LASER INTERFEROMETER GRAVITATIONAL WAVE OBSERVATORY

Document Type	DCC Number	August 13, 2015
Test Procedure	T1500440-v1	
Hardware Watchdog PSoC Schematic and Code Changes		
B. Abbott, R. Abbott

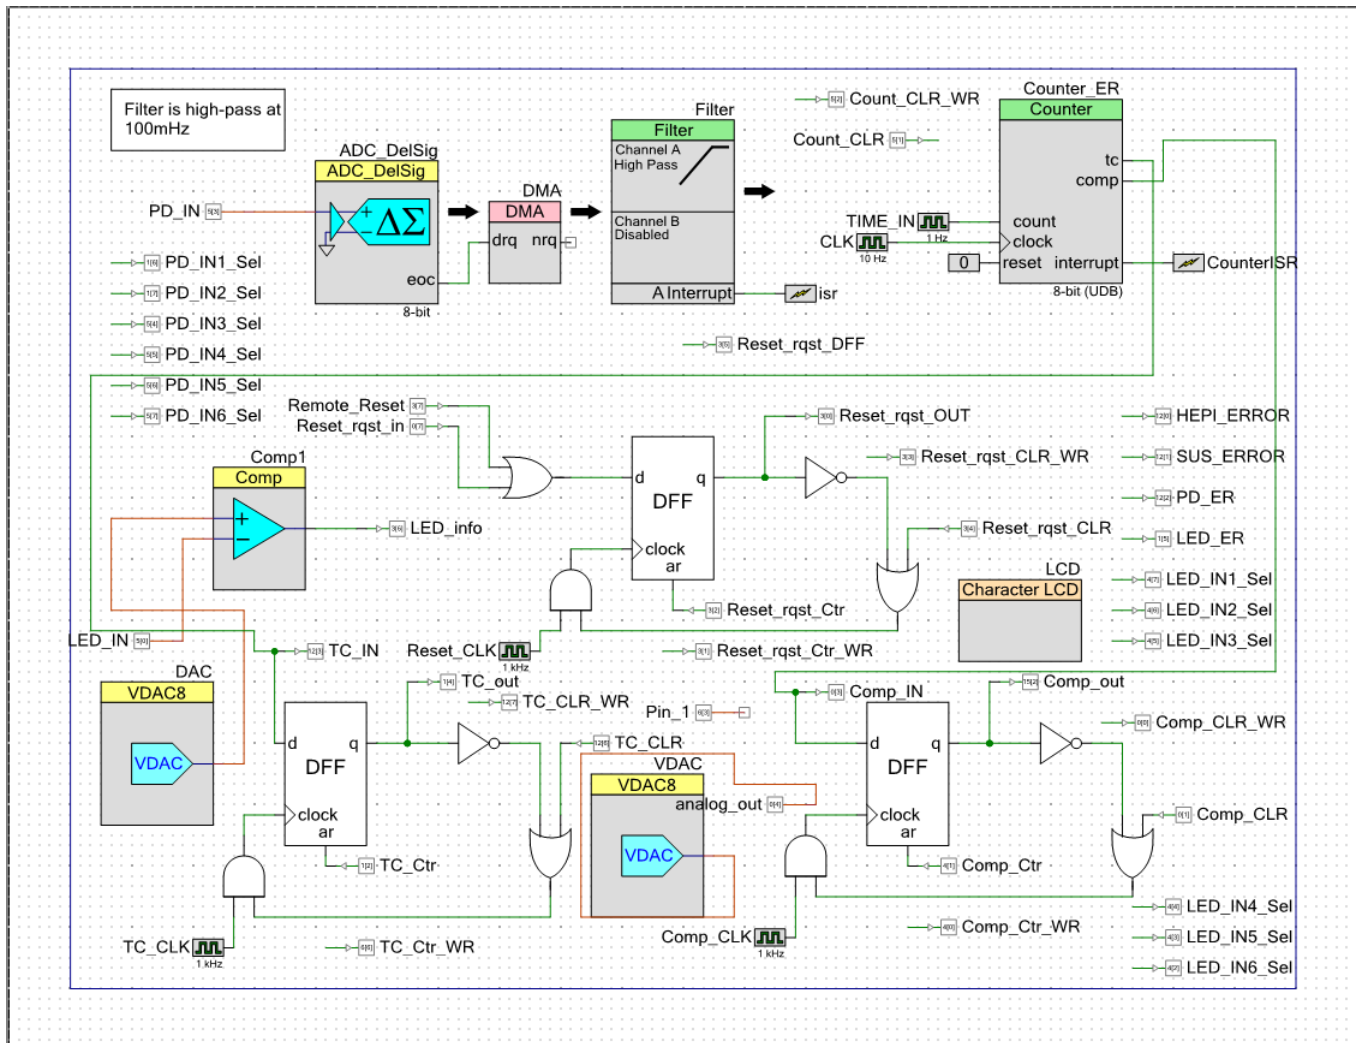
This is the schematic as it exists in the DCC as the “TopDesign.cysch” in a PSoC Creator 3.1 project file. We found it very difficult to follow and understand.

Before:

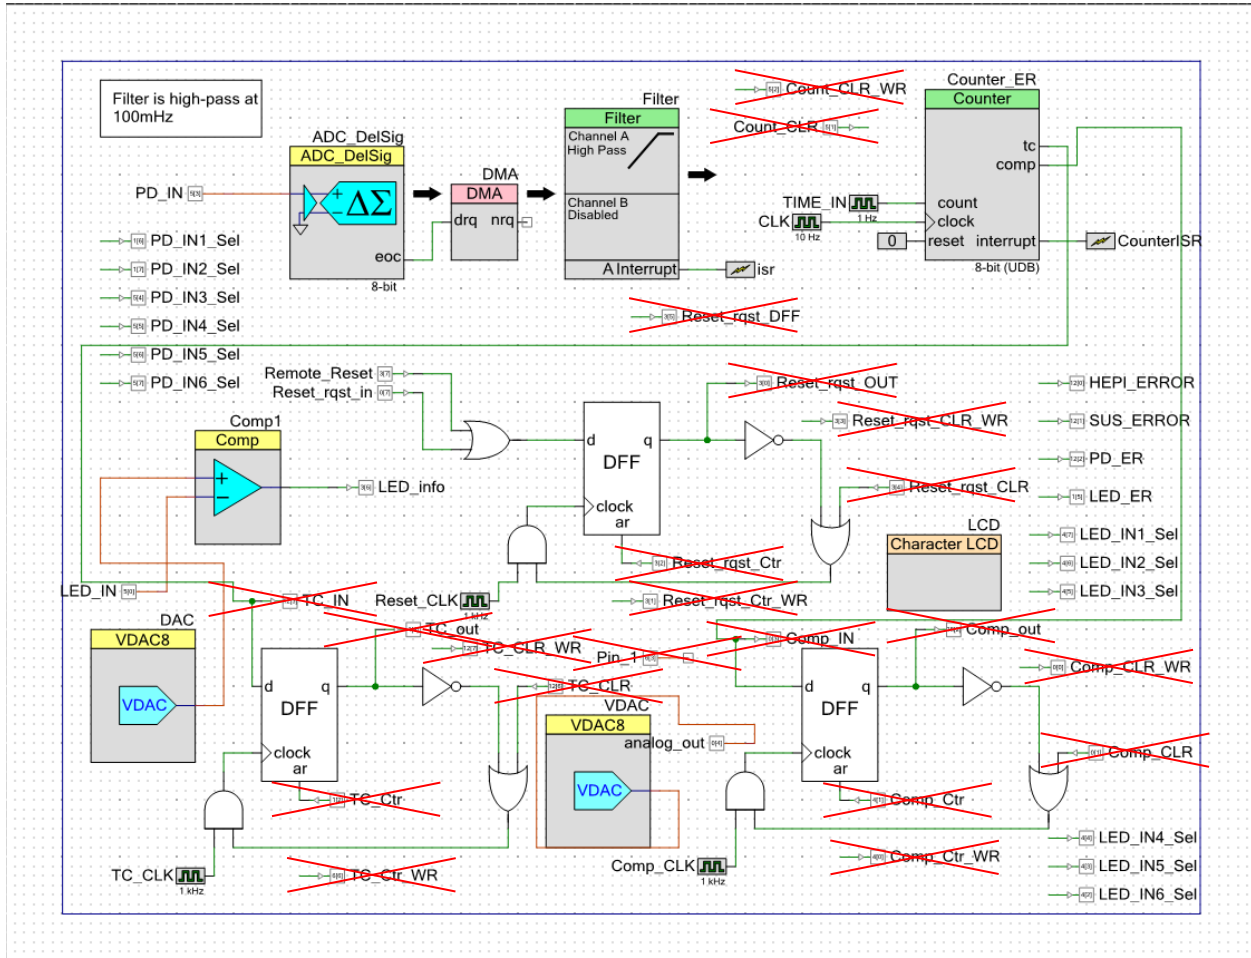
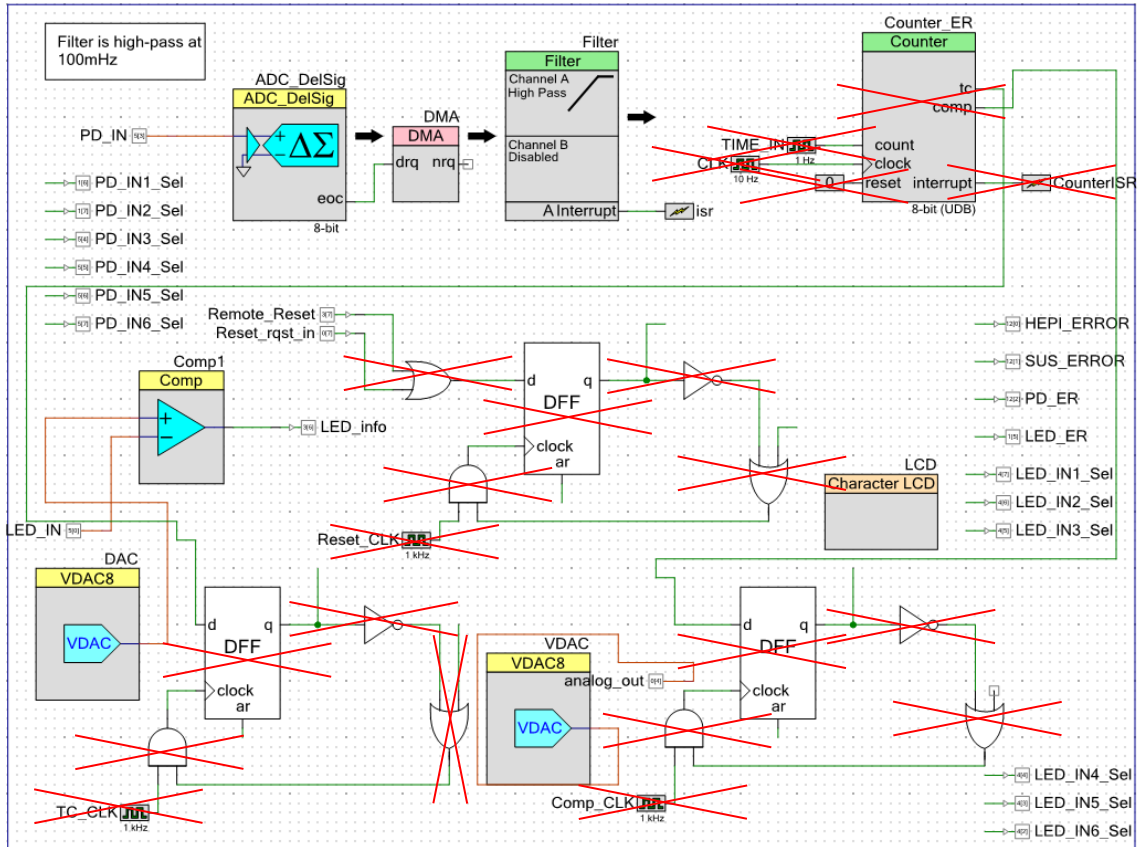
Pins were eliminated that were never used in the code, and were not wired on the hardware board at all. They were likely vestigial pins from older iterations of the design. The remaining pins were either MUX selector bits, Error output bits, the comparator output pin, the PD input signal or the Remote_Reset, and Reset_rqst_in which are both signals coming from the Hardware board, and are “OR”ed together in code, rendering the schematic “OR” symbol superfluous:

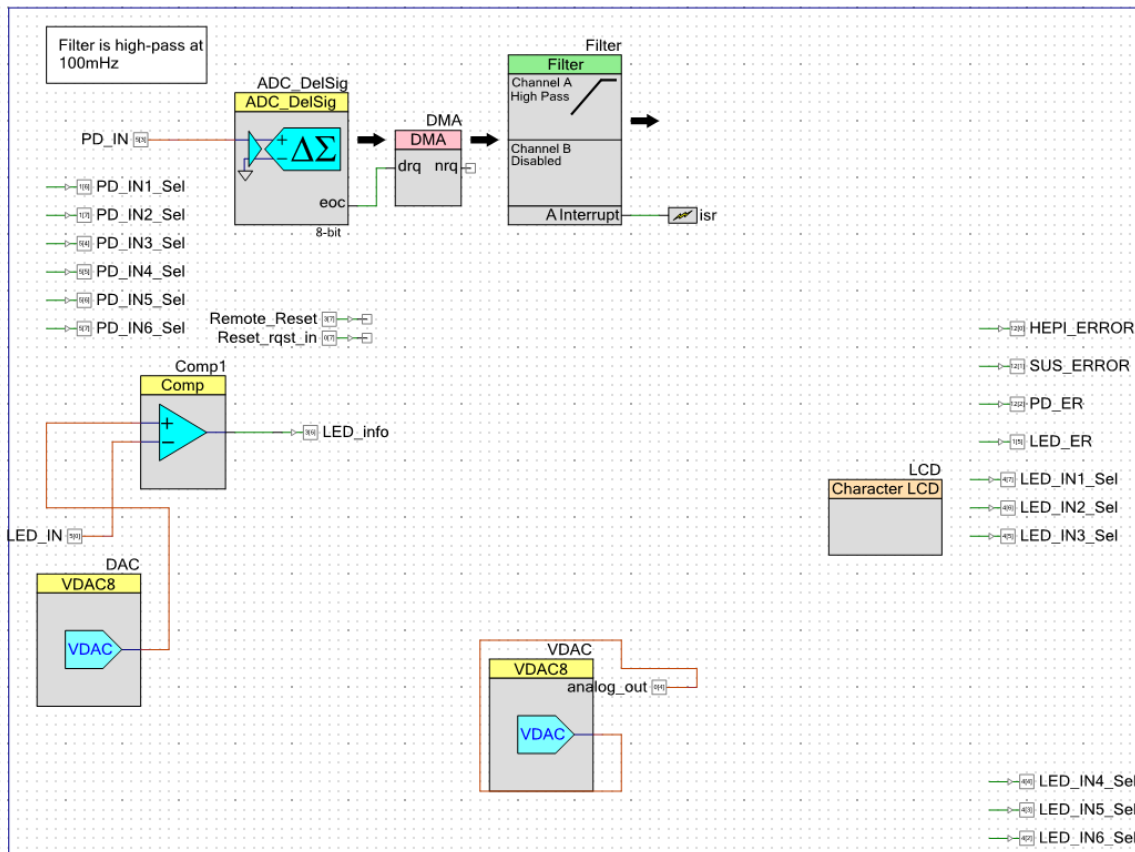
With those pins gone, it left logic gates, D-flip-flops, and a counter that all did nothing. I eliminated them, along with their individual clocks:

To this:

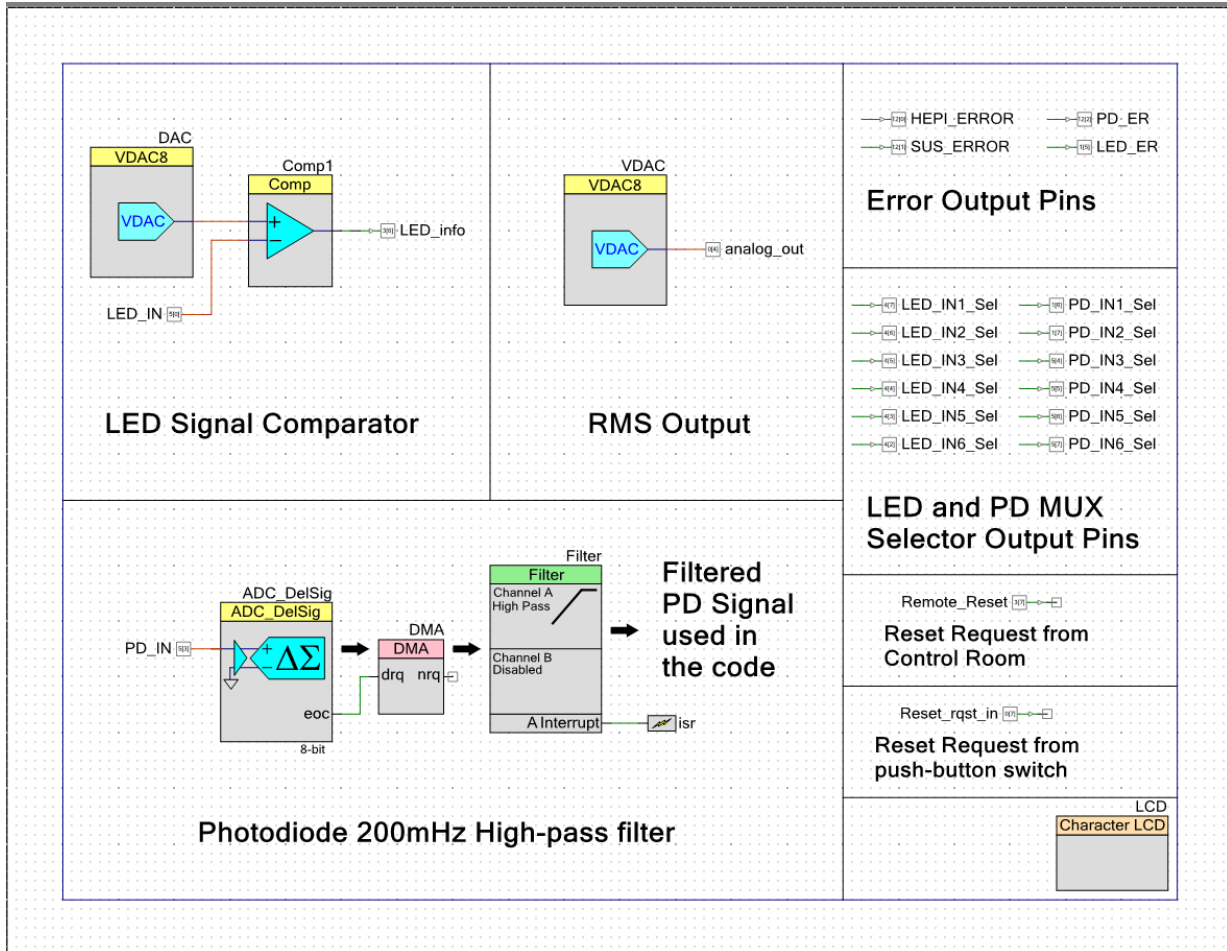
This left a pretty clean schematic that could be labeled and rearranged from this:
